Re: Pacific Gas and Electric Company, Poe Project (FERC No. 2107)

On behalf of Butte County, we comment on the "Initial Study Document, CEQA Checklist, and Proposed Mitigated Negative Declaration" (September 2017) ("IS/MND"). This letter supplements our July 17, 2017 comments on the draft water quality certification (June 2017) ("DWQC"), including the Rationale.

<u>Attachment 1</u> <u>Bardees Bar Road (October 11, 2017)</u>

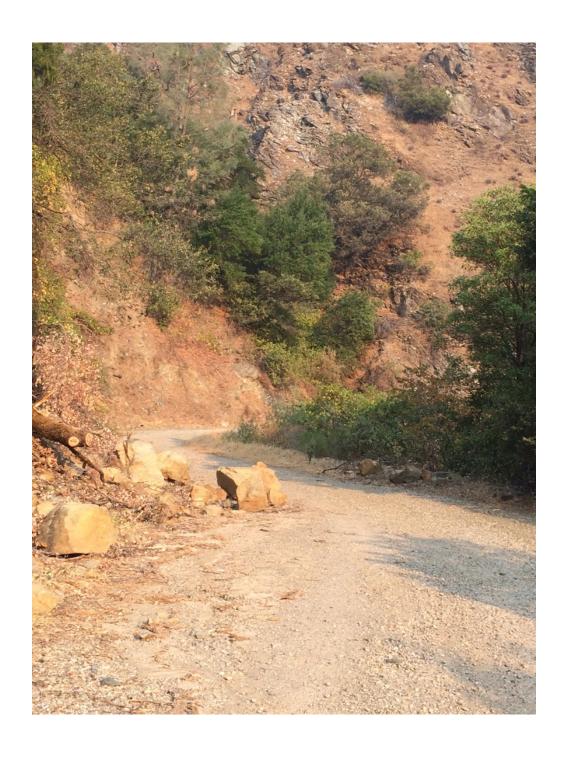
CEQA requires comparative analysis of alternative mitigation measures for an impact. 14 C.C.R. § 15126.4(a)(1)(B). As discussed in our July 14, 2017 comments, the IS/MND does not specifically analyze the County's proposal of a flow schedule, certain facility improvements (such as a new trail from Bardees Bar Road to Poe Beach), funding for law enforcement related to recreation, the North Fork Feather Enhancement Fund (for off-site mitigation), and other measures to avoid, minimize, and compensate for the Project's continuing impacts on recreation. See NREA Comments, pp. 4 - 22. To emphasize one example, the IS/MND does not analyze a maintenance measure to correct the erosion and other degradation resulting from PG&E's use of Bardees Bar Road. See Butte County, DEA Comments, Exhibit 17. Attachment 1 shows the marginally passable conditions of the road. That said, we are very grateful for the several facility improvements proposed in DWQC Condition 8.
